Responses to RC1:

This manuscript presents the calibration algorithms used for the ACDL lidar onboard the DQ-1 satellite, with the analysis of the 532 nm nighttime polarization and high-spectral-resolution channels. The study is of significant interest to the lidar community, particularly as the launch of the EarthCARE ATLID lidar in May 2024 presents opportunities for comparative analyses between these two advanced lidar systems. This paper was originally submitted in May 2024, and my previous reviewer comments, along with the authors' responses, are available at: <https://egusphere.copernicus.org/preprints/2024/egusphere-2024-588/> under Anonymous Referee #1.

Responses to RC2:

The manuscript describes the nighttime calibration of the spaceborne HSR lidar ACDL/DQ-1. It is important to clarify how the signals are calibrated. There is some heritage of the CALIPSO mission, and something to learn for the new EarthCARE mission. At parts the authors present great details, but at others the authors go rather quick over some issues. In general, the paper is good and should be published after major revisions.

Figure 10: The percentage of rejected profiles for ACDL nighttime calibration (July). (a) Parallel-polarized channel, and (b) HSRL channel

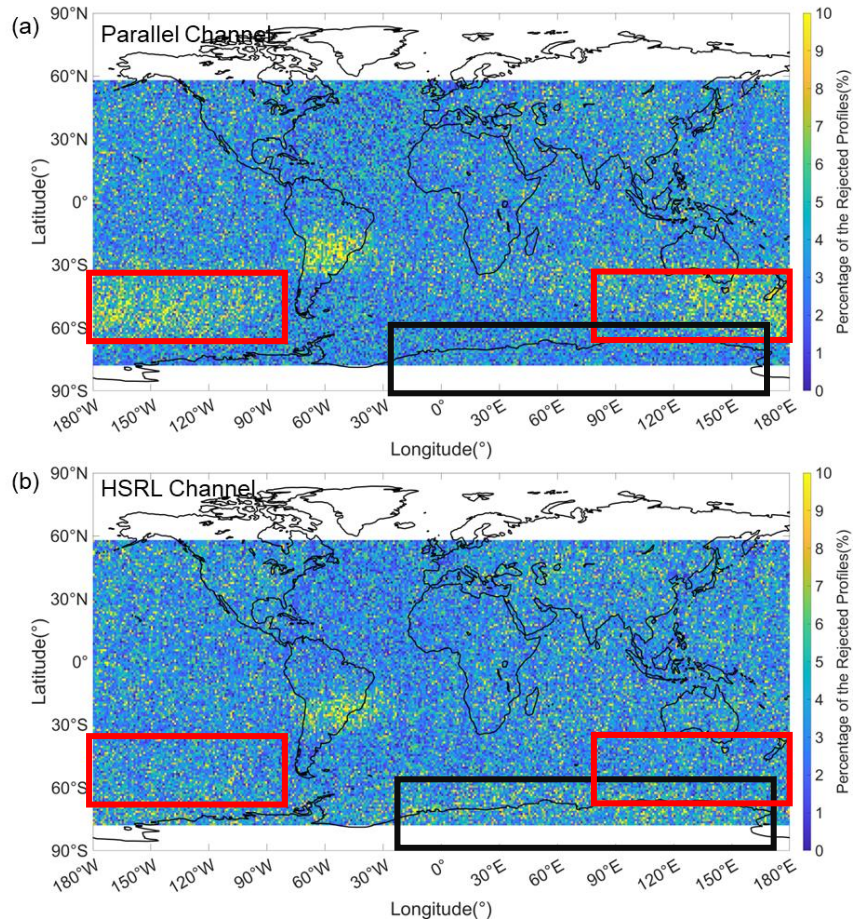
15. Fig. 10. What are the differences between the parallel channel and the HSRL channel and why? What is the difference in this figure compared to the one shown in your response to reviewer #2 from the previous submission? What happened to the high values above Antarctica?

AR: Thank you for pointing out this issue. As demonstrated in Figure 10, the probability of filtered data is less than 10% for both the parallel and HSRL channels. However, the latitudinal extent near the South Pole effectively filters out a greater number of profiles in the parallel channel. This

phenomenon is attributed to the observation that the HSRL channel exhibits a diminished received signal for high-energy events within this particular region when compared to the parallel channel. Consequently, the HSRL channel signal within this region is found to be less filtered (as shown in Figure 9a and 9b).

In the revised manuscript, the high filtering in the Antarctic has been eliminated due to the modification of the background acquisition algorithm. This modification represents the most significant difference between this submission of Figure 10 and the previous manuscript.

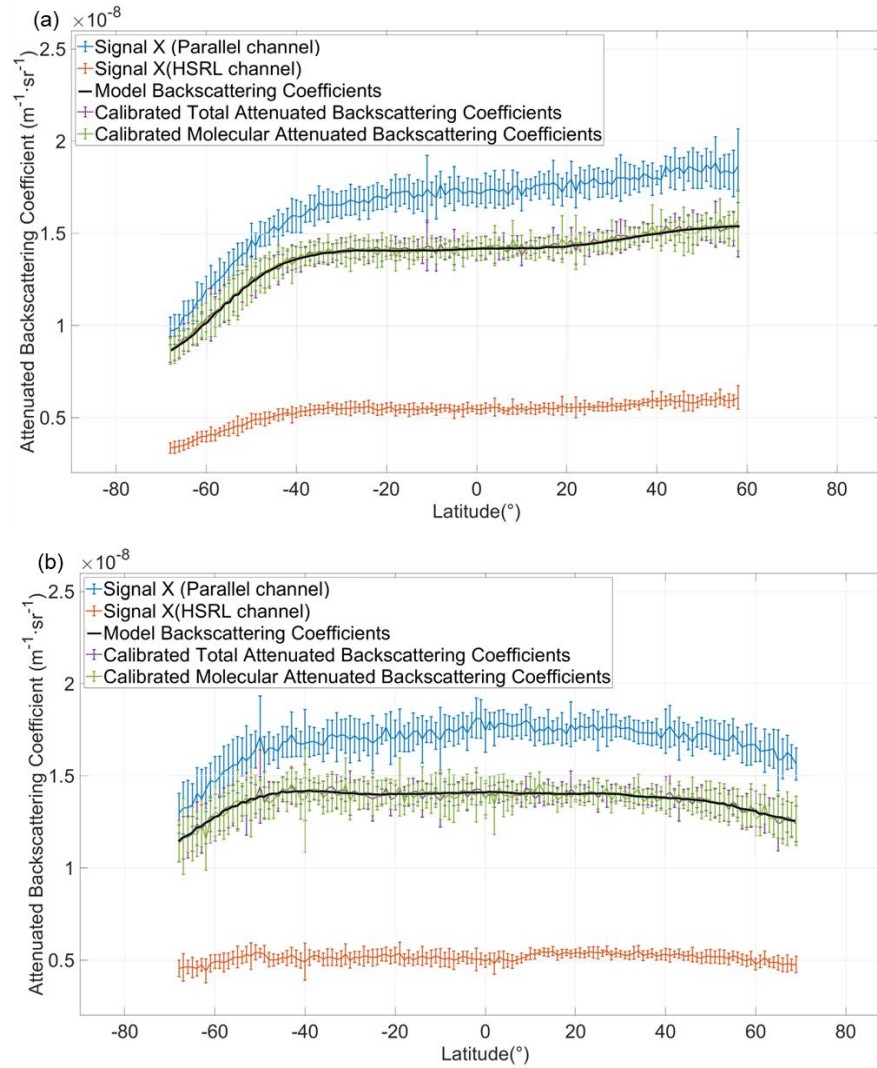
18. In Fig. 11 it is hard to spot the yellow line. The orbits (c+d) are not necessary to understand the figure.

AR: Thank you for raising the issue. The Figure 11 has been updated in the revised manuscript as follows:

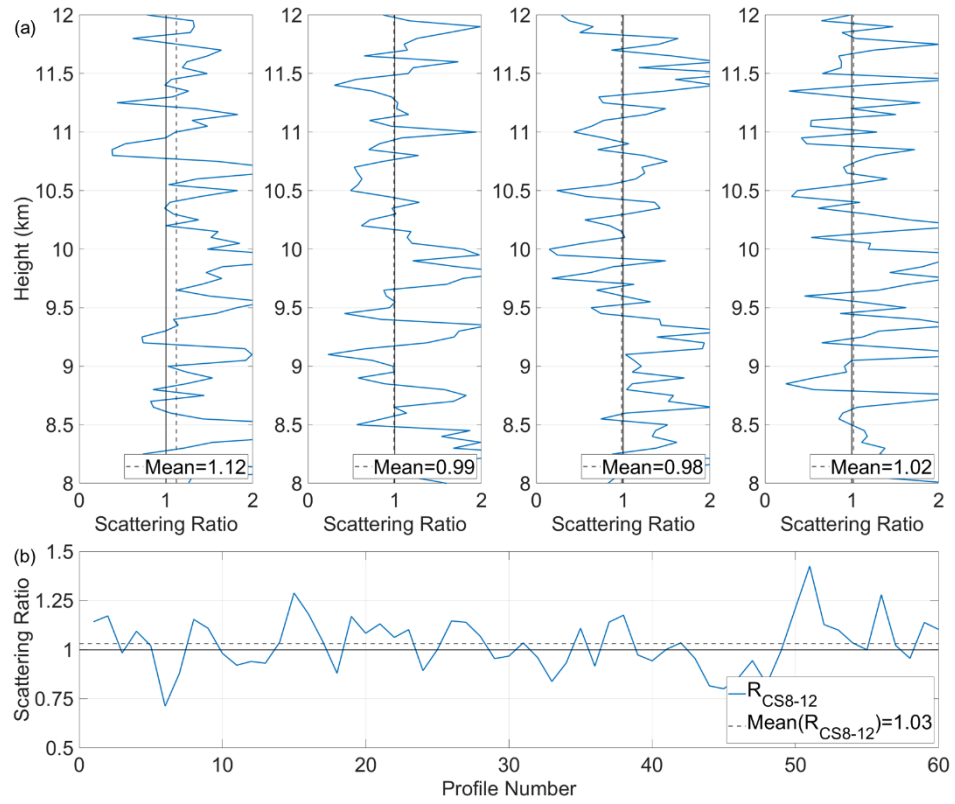
20. In the text and caption of Fig. 13 you swapped the naming of “dashed” and “solid” lines. Furthermore, the scales in Fig. 13 could be improved. In a) it would be sufficient to show the x-axis between 0 and 2. In b) you could zoom in the y-axis and provide some more minor ticks.

AR: We feel sorry for our carelessness. The Figure 13 has been updated in the revised manuscript as follows:
